Canadian Environmental  
Assessment Agency

# Analysis of IAMGOLD Corporation's Proposed Changes to the Côté Gold Mine Project

February 2019

On September 11, 2018, the proponent submitted an Environmental Effects Review Report to inform the Agency of proposed changes to the design of the Project pursuant to conditions 2.10 and 2.11 of the Decision Statement.

**Figure 1. Comparison between previous and currently proposed project layouts**

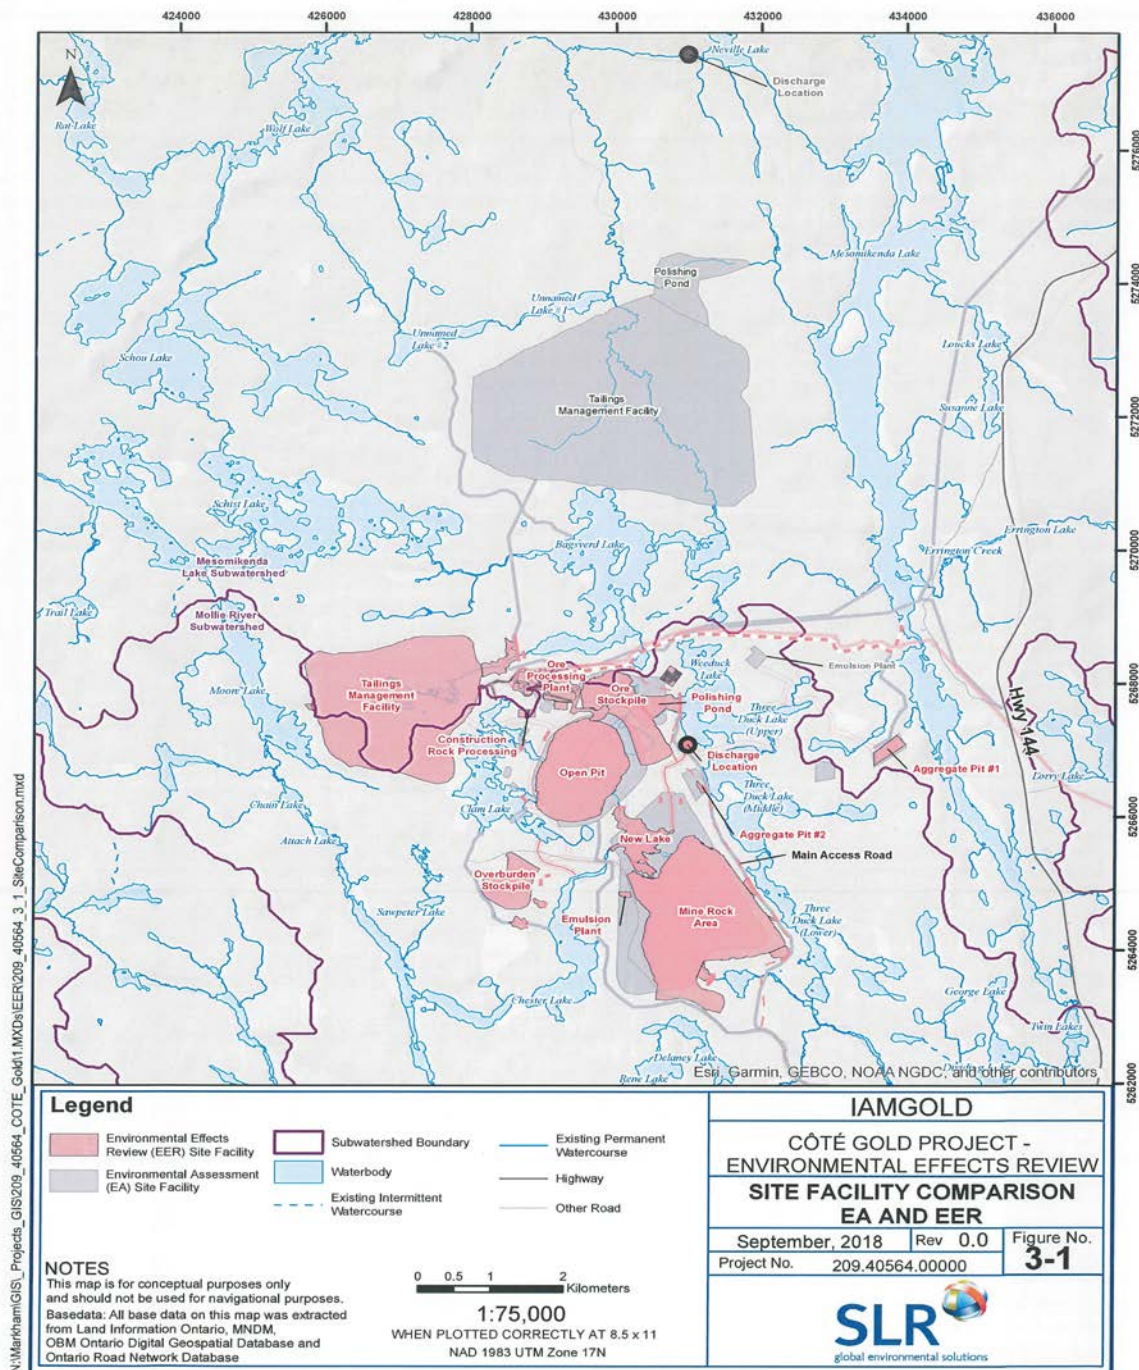
The key changes to the Project (Table 1; Figure 1) include a reduction in overall project footprint due to a smaller open pit, mine rock area and tailings management facility, as well as:

- relocation of several project components including the tailings management facility, reclaim pond, polishing pond, final effluent discharge point, and overburden stockpile;
- modifications to watercourse realignments including creation of New Lake; and
- selection of an alternate transmission line alignment.
